APPLICATION NO. : H16 1094 92

Listed Building Consent

Description: Installation of security grilles

Location : 12 Market Place Spalding
Lincs

Drawing Title
PLAN & ELEVATION

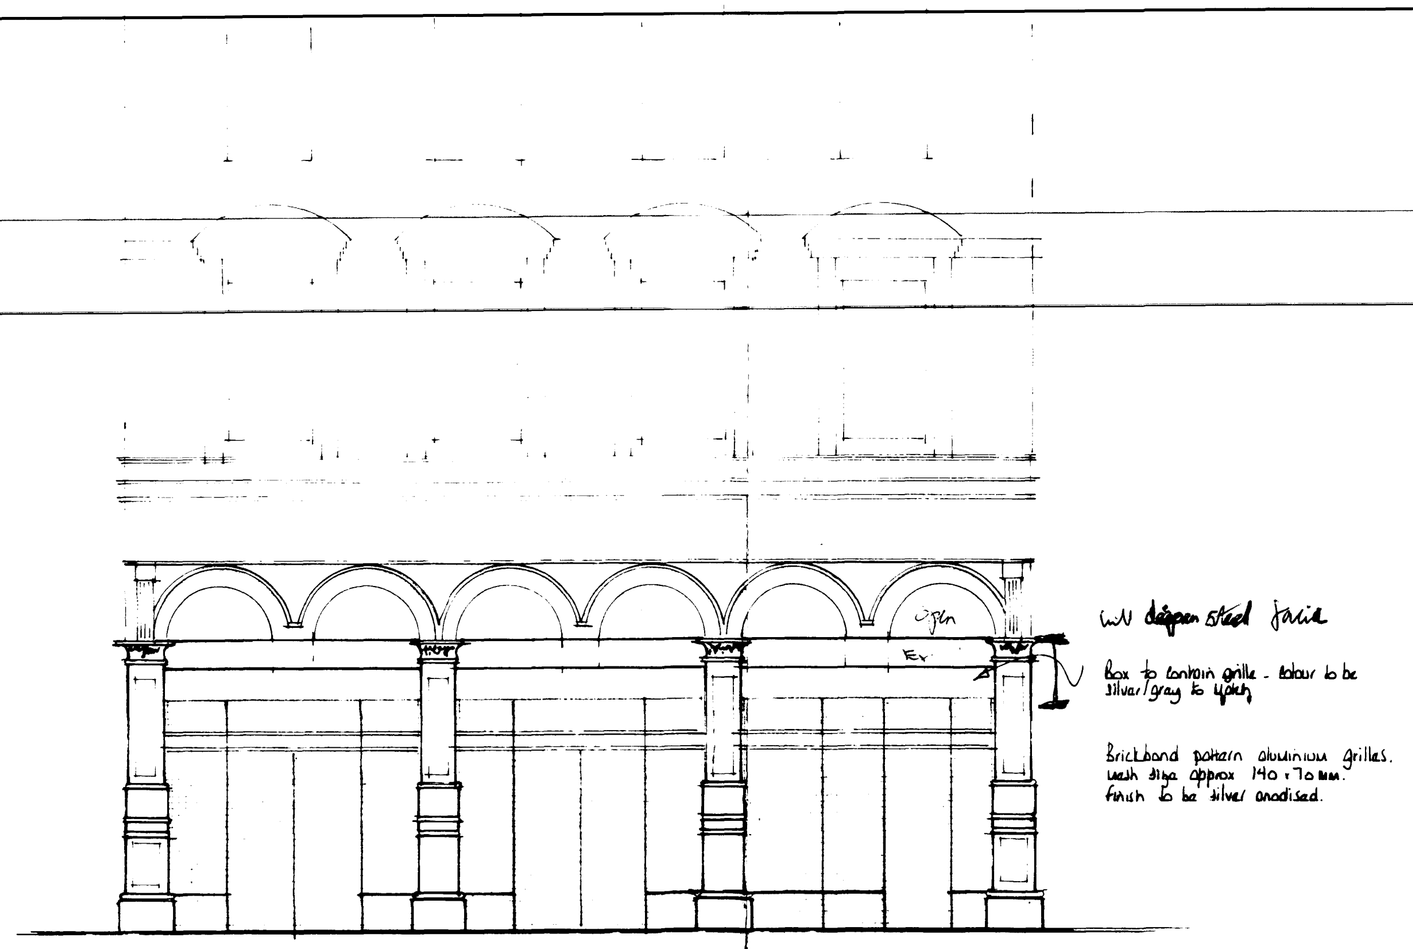
1 *In the opinion of the Local Planning Authority, the proposed manner of installing the box containing the grille in its closed position will result in unacceptable harm to the character and appearance of this Grade II Listed Building, and will also harm the appearance of this part of the Conservation Area, contrary to Policy E1 of the Spalding and Pinchbeck Local Plan, and the aims of Section 72 of the Listed Buildings and Conservation Areas Act of 1990.*

The proposal to install security grilles involves the addition of a further beam line below the existing one to house the roller shutter. This will give a much heavier look to this horizontal member and spoil the vertical proportions of the openings.

Although the need for the security shutters can be understood, they are always best integrated when the box can be concealed. It should be possible for the box to be housed behind the beam. This would involve cutting into the shop windows and also altering the end display area. However, it should be possible to cut an opening into the glazing and seal around it, so that the box could be introduced into that position and not be visible from the front.

5 In this instance, the proposal is to mount this box arched immediately below the horizontal beam that runs below the heads of the front, effectively doubling its depth. This it is felt, would wholly destroy the proportion of the shop front and would, on a Listed Building in a Conservation Area, be unacceptable.

2 A meeting was held on site, when your officers recommended that the box be mounted behind the existing transom, i.e. out of sight. This would involve dismantling and replacing some of the existing glass sheeting, which the applicants felt they did not know how to do. They put forward a scheme for demountable gates, i.e. ones that would be removed each day, which were felt acceptable. However, on perusing the original construction plans, it was thought by both parties that it would be possible to fit the box within the existing transom, as there appeared room beneath the RSJ that it housed. It was left that this scheme would be pursued by the applicant and no further discussion was held of other alternatives.

5 In addition there seems no reason why the grille should not be in the form of horizontally sliding gates, housed when closed within the stone pillars, which are not solid, but clad steel columns which carry the weight.

6 Fortunately, it does appear possible to mount the box behind the beam and thus largely out of sight. It would involve cutting into the glasswork of the windows, but the Consultant Architect considers this to be possible.

Drawing Title
PLAN & ELEVATION

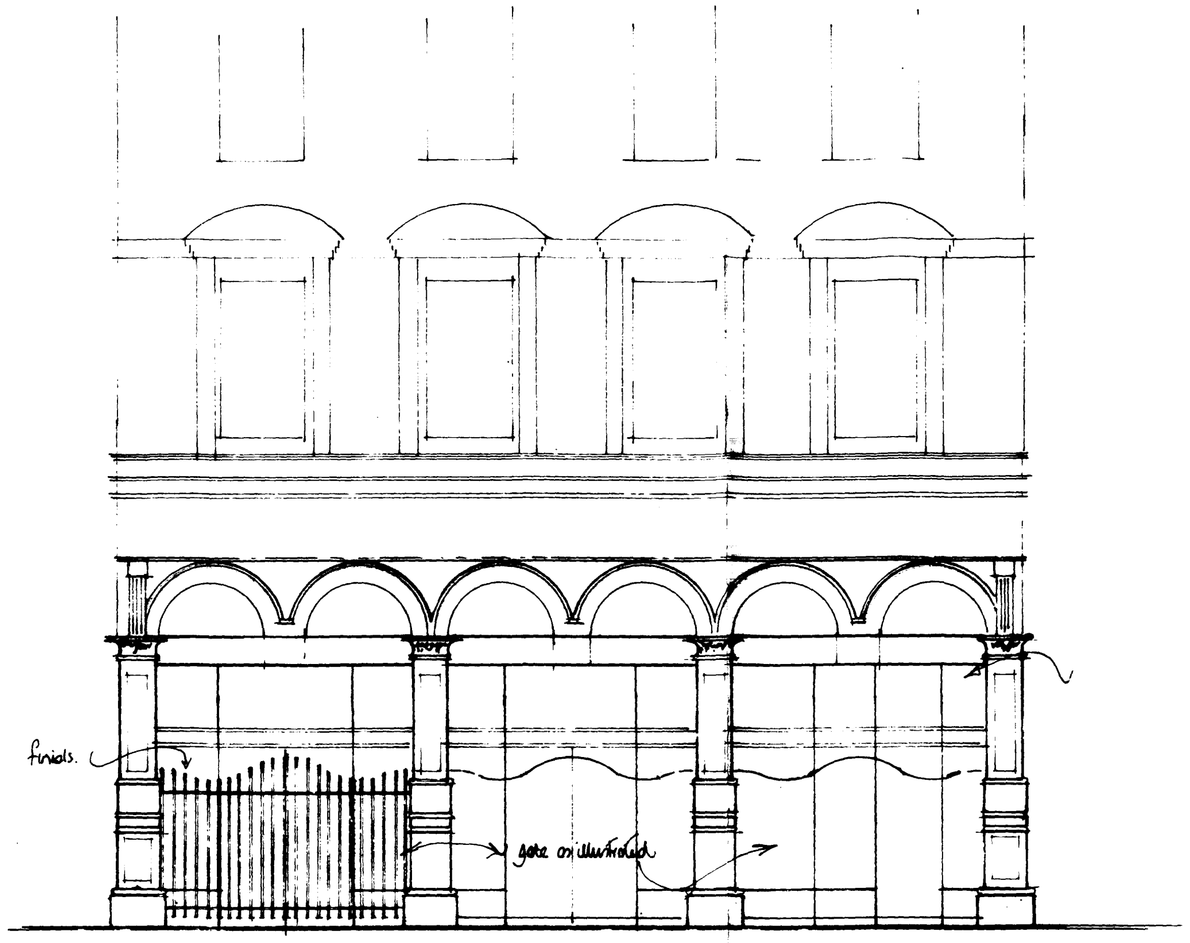
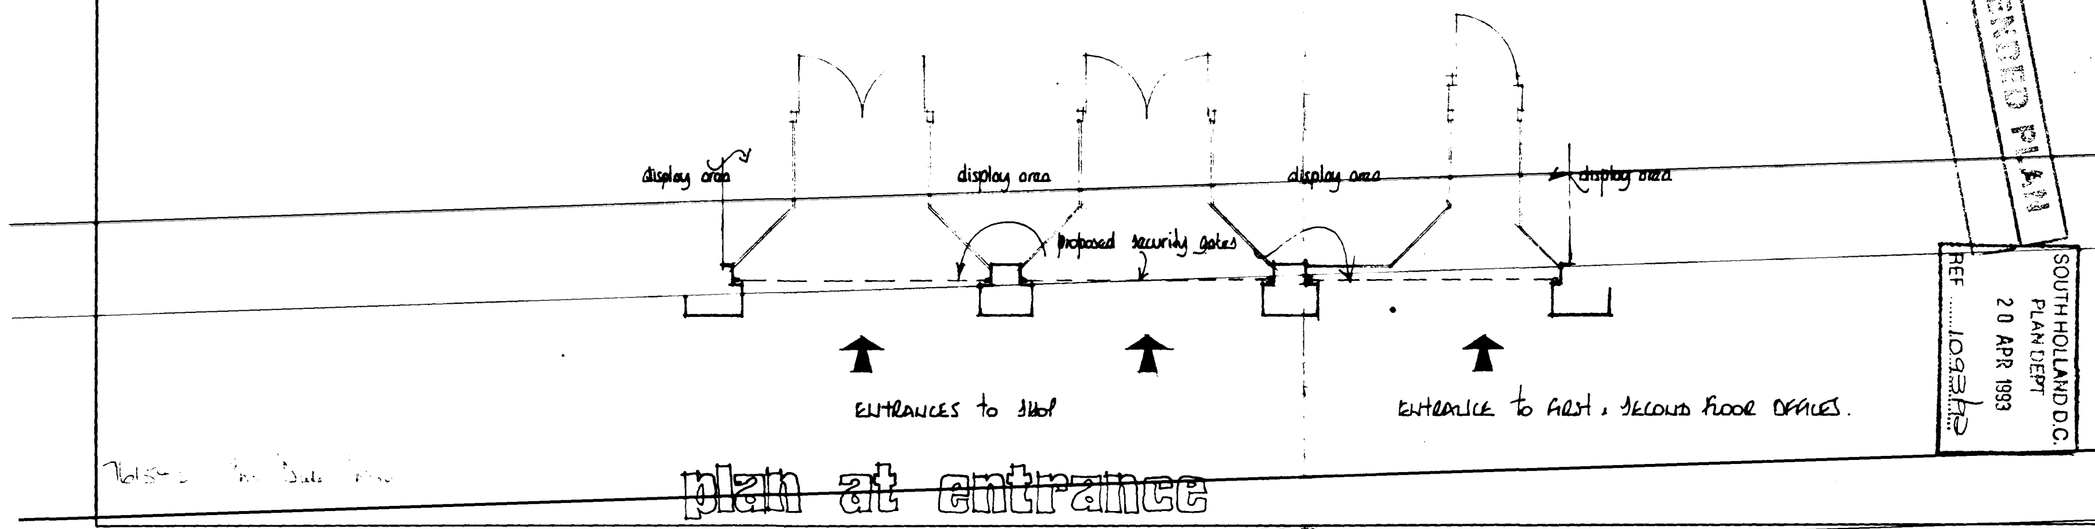
1 The applicants have now submitted an amended plan showing the substitution of the original grilles with demountable gates, which now appear to be acceptable to the insurers.

2 It is considered that the amended proposal is acceptable.

1 Before the gates are erected details, at a scale of 1:20, of their design and construction, showing clearly the size and cross-section of the metal to be used and any design features shall be submitted to and approved by the Local Planning Authority.
